August 7, 2014

Re: Amended RCRA Post-Closure Plan - Slag Pit Sump
FMC facility, Pocatello, Idaho - RCRA ID #IDD070929518
Incorporation of RCRA post-closure elements with IRODA implementation

FIGURE 1

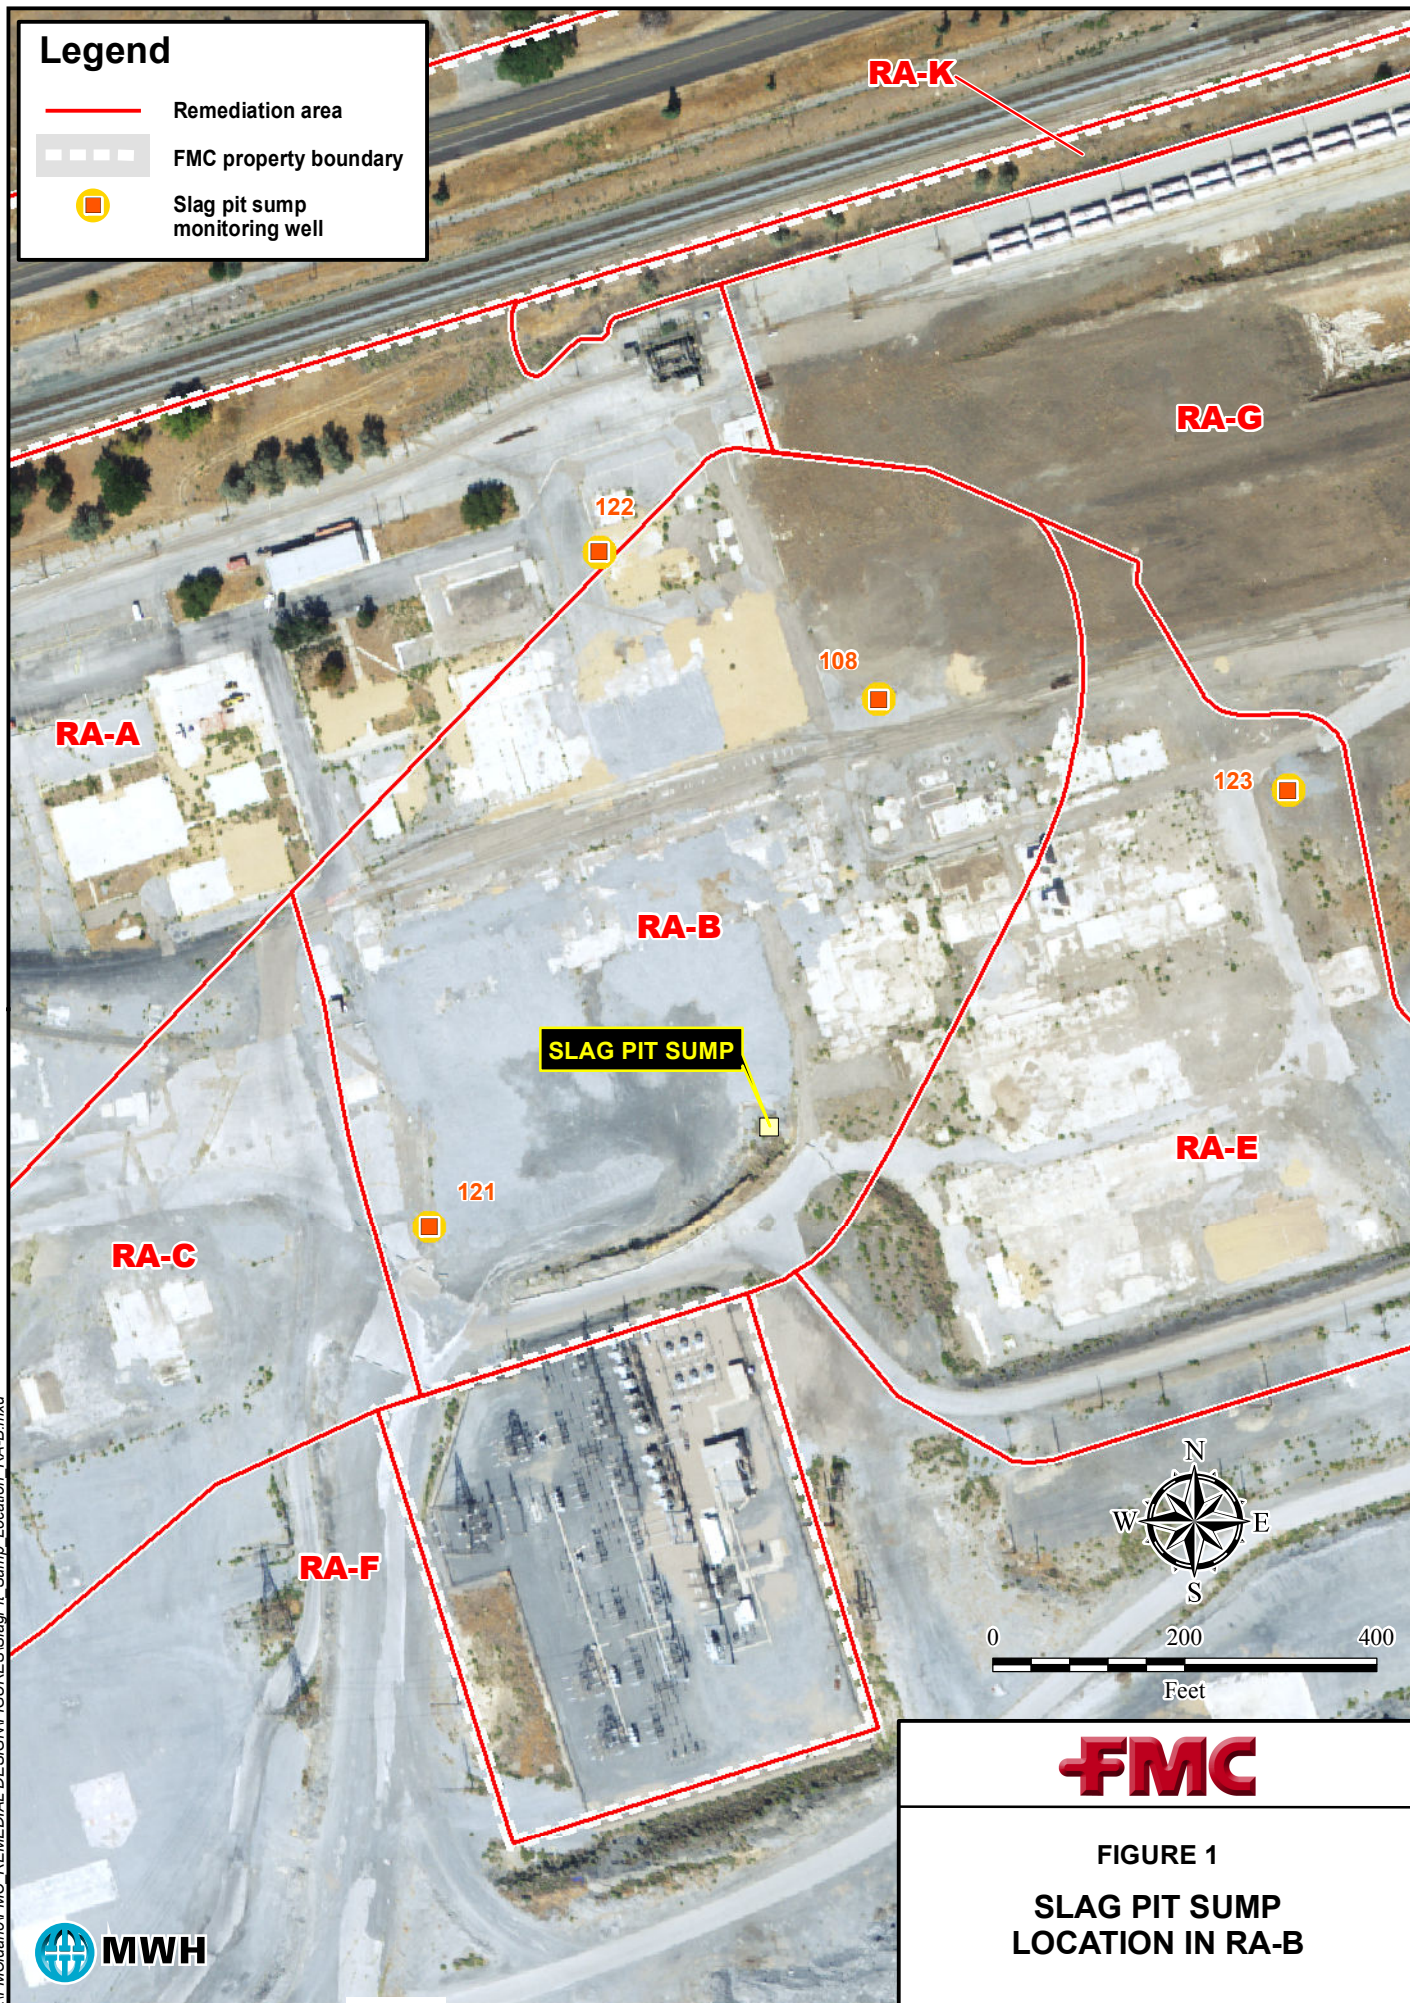
The SPS is located in the former slag pit within RA-B as shown on the attached Figure 1. In order to meet the objectives of preventing the infiltration of rainwater and preventing migration of contaminants to groundwater, the former slag pit and more generally the entire area within RA-B will be filled to the grade specified in the Remedial Design Engineering Design Submittal (submitted to EPA on July 18, 2014). This grading is designed to prevent run-on and drain precipitation laterally off of the ET cap on RA-B. Inherent in this design is the placement of more than 25 feet of fill over the closed SPS. The SPS closure caps (the interim and final asphaltic concrete caps) will remain in place. Implementation of the IRODA remedy will provide additional protectiveness to the existing SPS closure system, which was constructed to meet RCRA performance standards, and will continue to meet those standards with added protectiveness after the CERCLA-required filling, grading and installation of the ET cap is completed.

As a result of this additional protectiveness, visual monitoring and maintenance of the 15' x 15' asphaltic concrete cap as specified in the post-closure plan approved by EPA in 2005 will no longer be possible. Rather, the amended post-closure plan reflects changes to integrate the RCRA and CERCLA caps, as specified in the IRODA and required under the RD/RA UAO. The amended post-closure plan continues to require inspection and maintenance of the closure area, though necessarily deleting references to such activities being conducted at the asphaltic concrete cap. The cover (i.e., surface of fill material and finally the ET cap) above the asphaltic concrete cap will be the subject of inspection and maintenance as prescribed in the amended post-closure plan. In addition to inspection pursuant to this amended post-closure plan, the entire RA-B cap and drainage system will be subject to inspection and maintenance pursuant to a final and EPA-approved CERCLA Operation, Monitoring and Maintenance (OM&M) Plan.
